**REPONSE TO NHDES COMMENTS ON RAP
Former Dagostino Rose Farm
Oak Street Extension
Exeter, NH**

**NHDES Site # 201203003
Project # 27859**

**Date of Letter: August 30, 2018
StoneHill Project No. 15046**

RE: Response to Comments
Supplemental Site Investigation and Remedial Action Plan,
Former Dagostino Rose Farm, Oak Street Extension
DES Site #201203003, Project #27859

Enclosure: Figure 9 – Remediation Areas

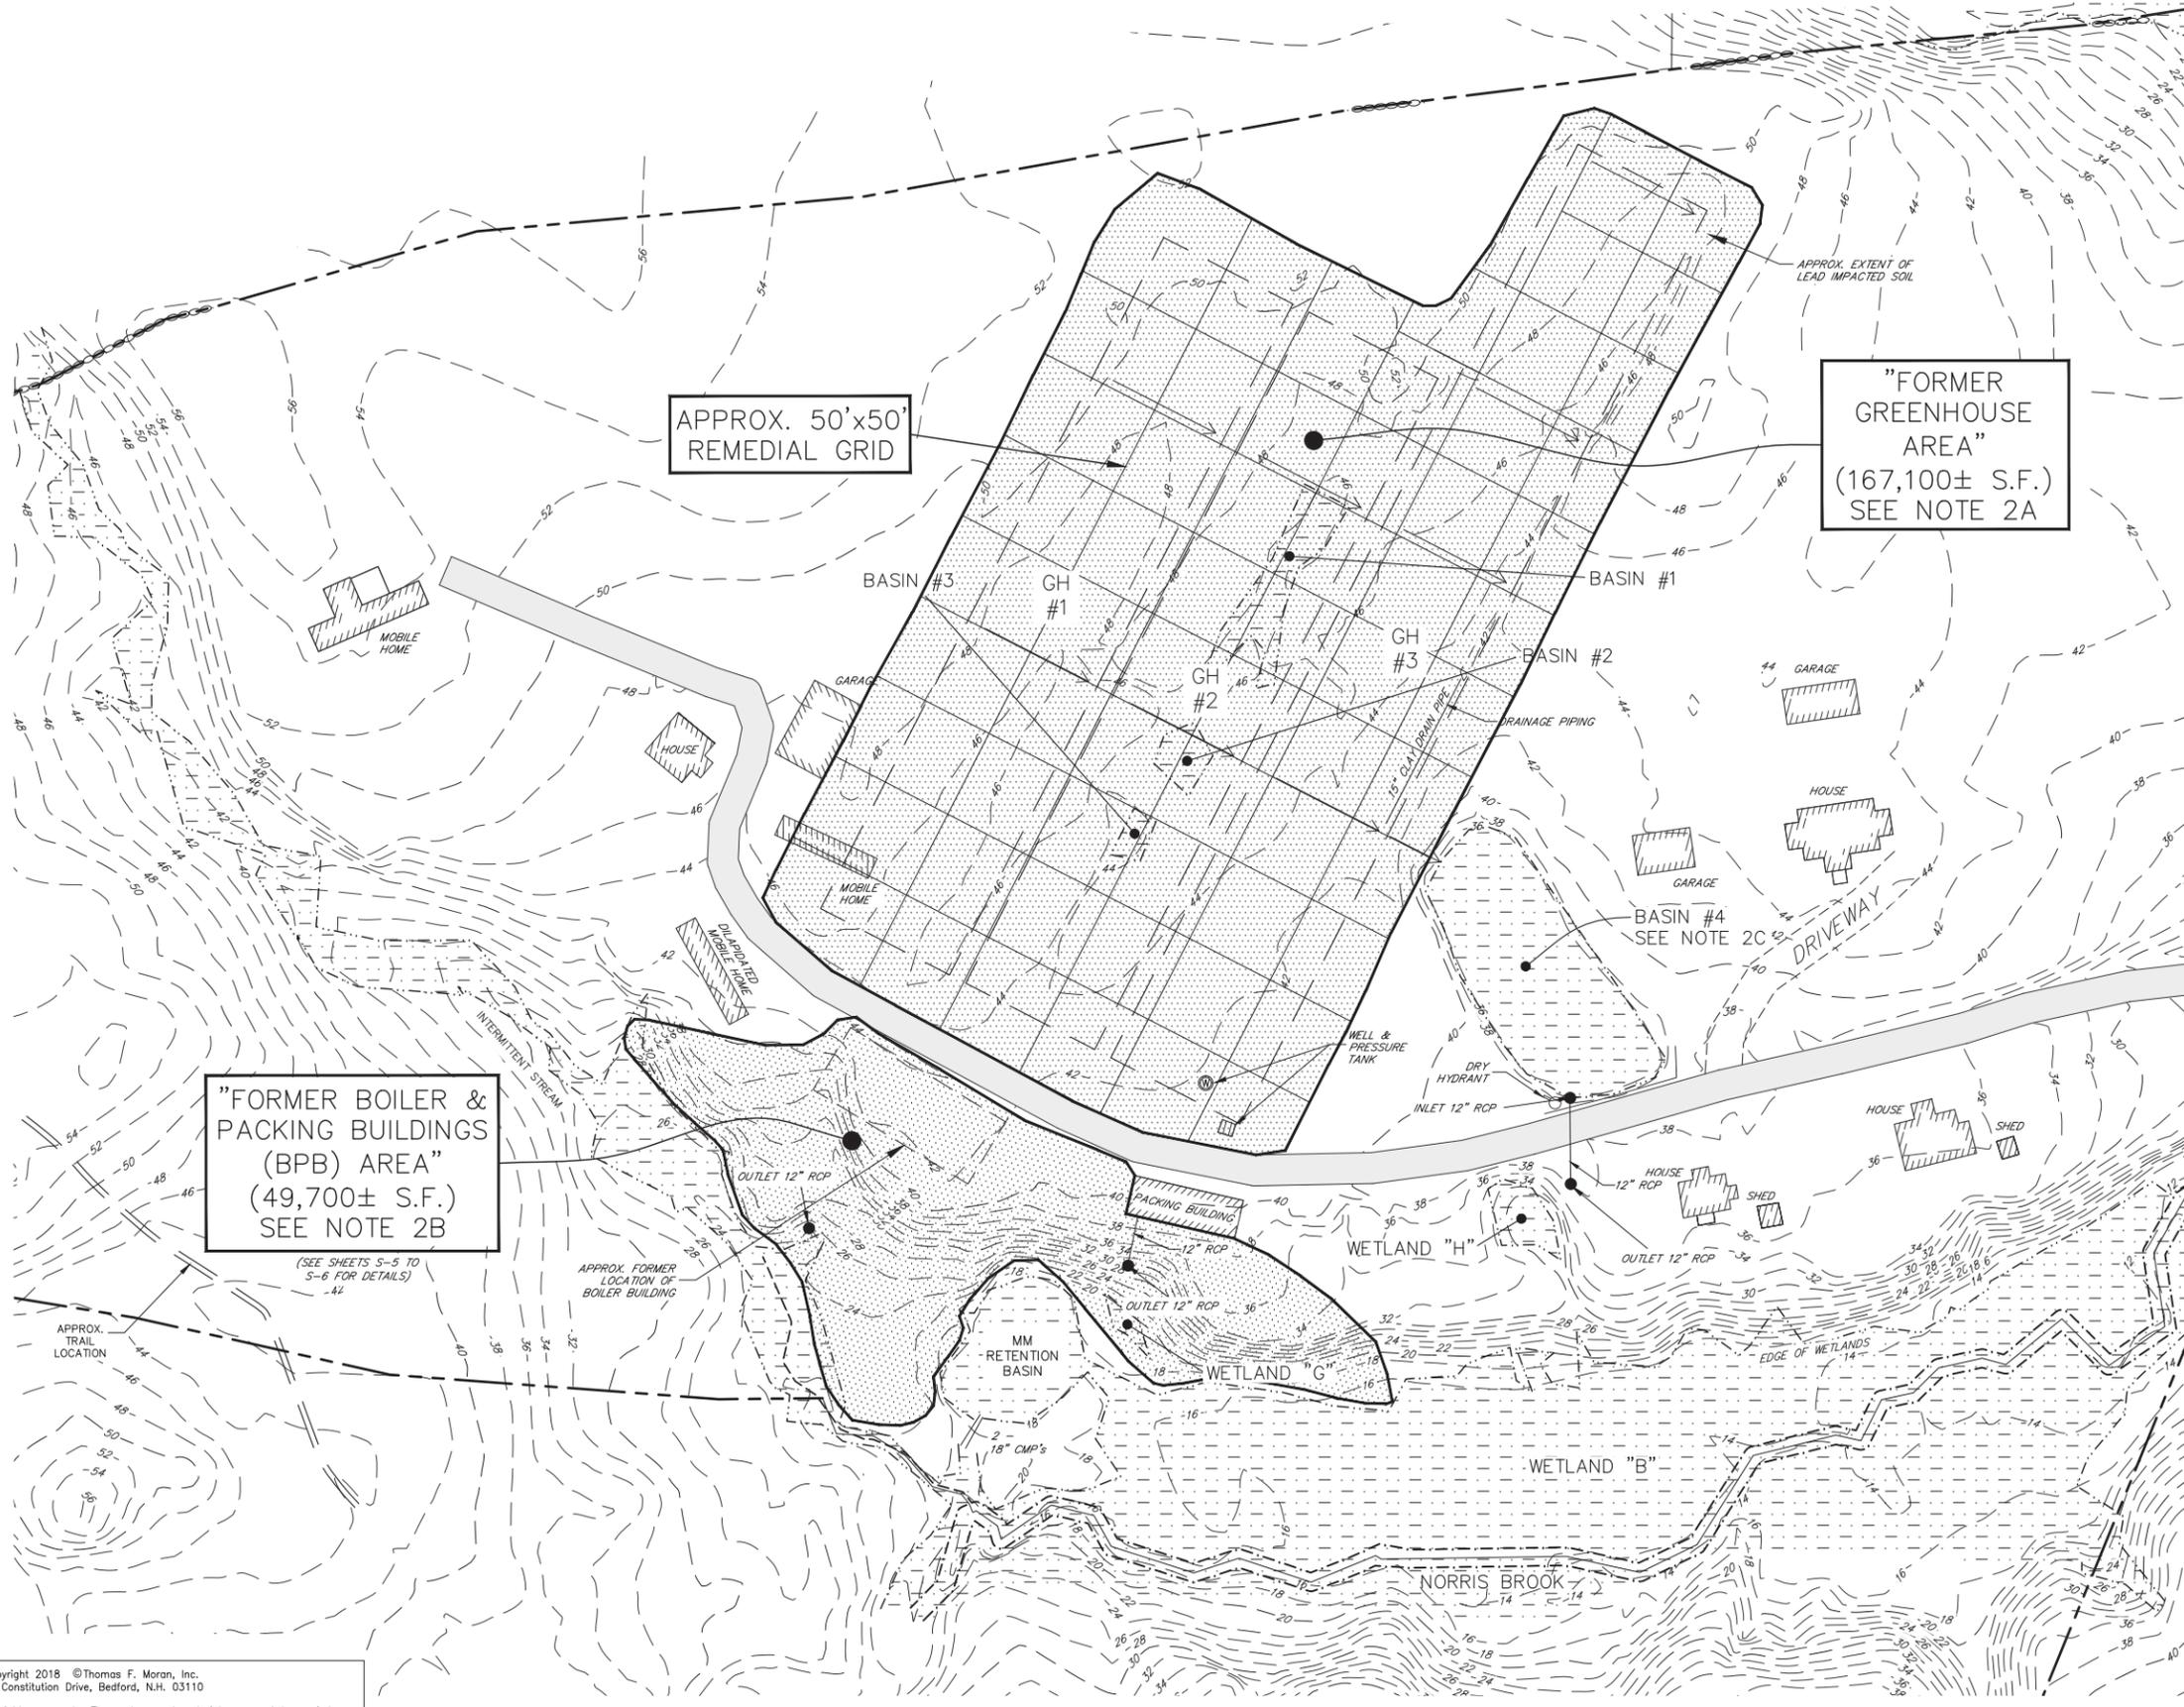
The grids shown on Figure 9 do not appear to extend a sufficient distance beyond the limits of the former greenhouses to include all the locations with lead SRS exceedances as shown on Figure 6. Please modify the grid layout on Figure 9 as appropriate.

- Response: The NHDES noted that the remedial target area depicted on Figure 9 for the removal of lead contaminated soil did not encompass all the sample locations where elevated concentrations of lead in soil were shown on Figure 6. The intent of the Remedial Action Plan (RAP) is to remove lead contaminated soils in excess of the SRS, including locations of elevated lead contaminated soils noted outside of the immediate footprint of the former greenhouses. A revised Figure 9 with extended grid boundaries has been prepared and is attached.
